# UNITED STATES PATENT AND TRADEMARK OFFICE

APPLICATION NO.	FILING DATE	FIRST NAMED INVENTOR	ATTORNEY DOCKET NO.	CONFIRMATION NO.
10/090,221	03/04/2002	James L. Dunn	P6228	3497

## Office Action Summary

## DETAILED ACTION

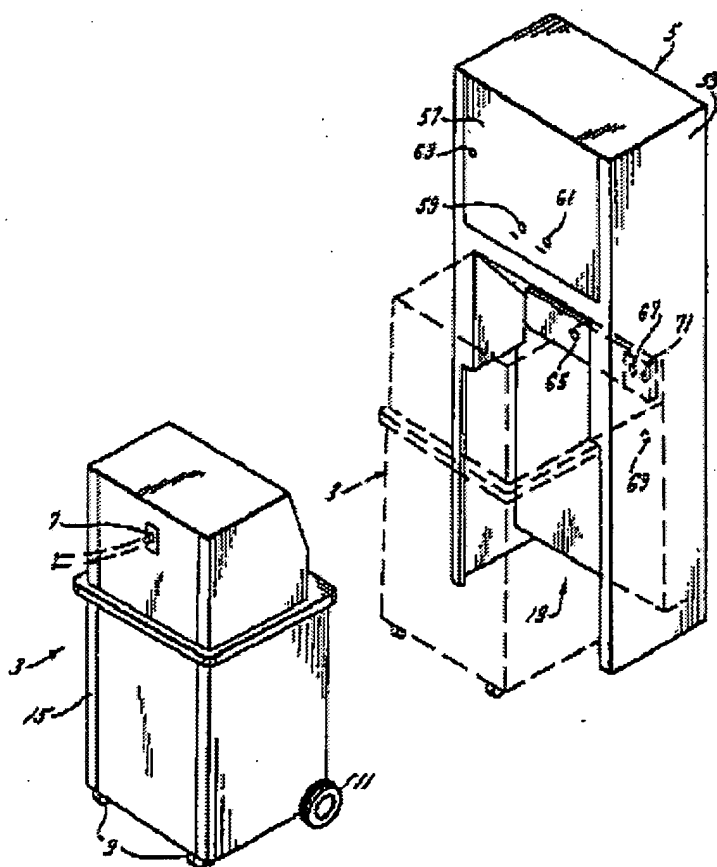
Parker teaches a cart (3) for collecting medical waste comprising a body (15) supported by a plurality of wheels (11);

a container (81) supported by said body (15) and having a drain port (53) therein;

a cap positioned on said container (81) and including a patient port (31) and a vacuum port (7) said patient port (31) adapted to selectively communicate with a suction line (33) and said vacuum port (7) adapted to selectively communicate with a vacuum source (fig. 9); and

a liquid level detector (21) in communication with said container (81);

whereby medical waste is collected in said container (81) through a suction line (33) connected to said patient port (31) when said vacuum port (7) is connected to a vacuum source (fig. 9) and the collected medical waste in the container (81) may be detected via the liquid level detector (21)(see fig. 1, below).

Regarding the container cap, the container (81) taught by Parker is designed to operate under a vacuum and inherently has some sort of cap to provide the sealed enclosure necessary to provide such a vacuum.

Regarding the limitations concerning the container being adapted to selectively communicate with a drainage station, there is no physical structure recited in the claimed invention which is directed to a drainage station.

Regarding claim 2, Parker teaches a vacuum regulator (35).

Regarding claim 9, Parker teaches a filter (75) in communication with said vacuum port (7).
